# febi 40308

To fit:  
various Volkswagen, Audi, SEAT and Škoda models

## Auxiliary belt kit with belt tensioner and bolt

Figure 1

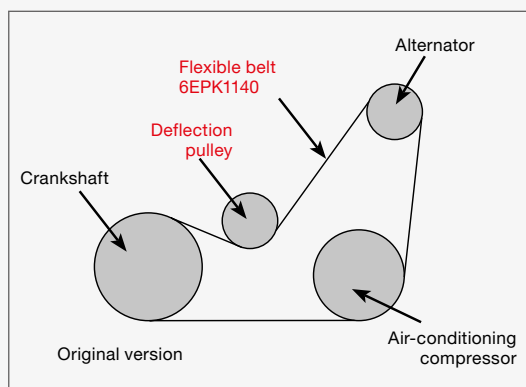
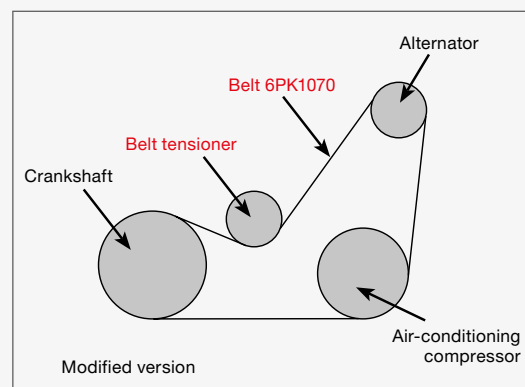
The original version of the auxiliary belt drive was driven by an elastic multi-V belt and a deflection pulley which suffered from wear, leading to insufficient tension of the auxiliary belt. (Fig 1) To improve the NVH (noise, vibration, harshness) characteristics, the vehicle manufacturer redesigned the components of the auxiliary belt drive.

The elastic multi-V belt and deflection pulley have been superseded using a sprung-loaded tensioner and a conventional multi-ribbed V-belt. (Fig 2.) febi kit 40308 has all the components required to update the auxiliary drive to the latest OE specification. The parts are also available separately for vehicles that have already been modified, and are as follows: 37533 (auxiliary belt) and 102297 (tensioner assembly).
